SUBJECT: ISSUANCE OF AMENDMENTS - VOGTLE ELECTRIC GENERATING PLANT,  
UNITS 1 AND 2 (TAC NOS. M92172 AND M92173)

The amendments revise TS 3/4.9.4, Containment Building Penetrations, to allow the personnel airlock to be open during core alterations or movement of irradiated fuel within the containment.

GEORGIA POWER COMPANY  
OGLETHORPE POWER CORPORATION  
MUNICIPAL ELECTRIC AUTHORITY OF GEORGIA  
CITY OF DALTON, GEORGIA  
VOGTLE ELECTRIC GENERATING PLANT, UNIT 1  
AMENDMENT TO FACILITY OPERATING LICENSE

SAFETY EVALUATION BY THE OFFICE OF NUCLEAR REACTOR REGULATION  
RELATED TO AMENDMENT NO. 92 TO FACILITY OPERATING LICENSE NPF-68  
AND AMENDMENT NO. 70 TO FACILITY OPERATING LICENSE NPF-81

FIGURE 3.6-1

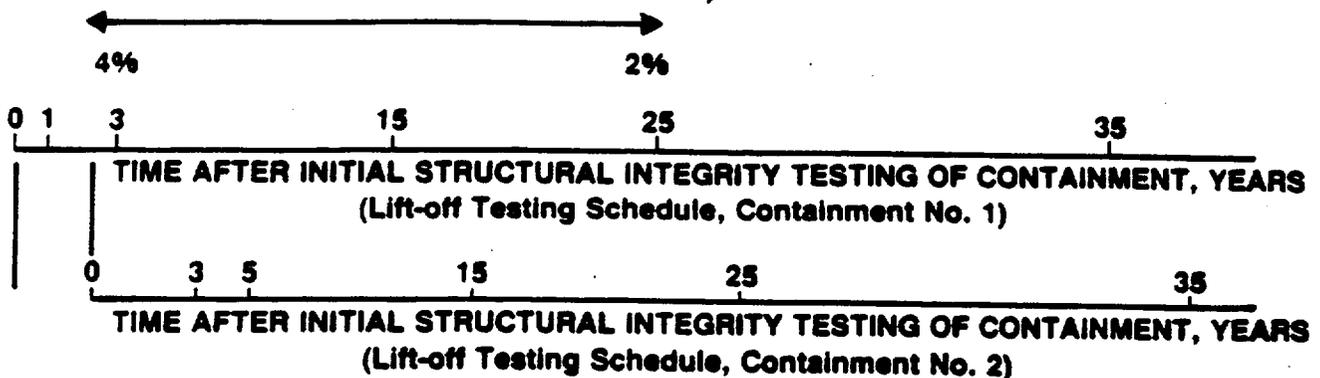
In addition to the changes to TS 3/4.9.4, the licensee proposed editorial changes to the index of the TS and to TS page 3/4 6-10. The staff reviewed the licensee's proposed changes and found them to be acceptable editorial corrections to the TS.

- a. The containments are identical in all aspects such as size, tendon system, design, materials of construction, and method of construction. The tendon system for Unit 2 does not provide for detensioning. Detensioning can be performed only on the Unit 1 tendon system.
- b. The 1-year inspection for Unit 2 will consist of a visual inspection only. No lift-off testing will be performed on Unit 2 until the 3-year inspection.
- c. There is no unique situation that may subject either containment to a different potential for structural or tendon deterioration.
- d. The Unit 1 and Unit 2 surveillances may be performed back-to-back to facilitate detensioning of Unit 1 tendons during the Unit 2 surveillance.
- e. In order to perform back-to-back surveillances on Units 1 and 2, the Unit 1 10-year surveillance and the Unit 2 5-year surveillance are to be performed between 5/1/95 and 11/1/95.
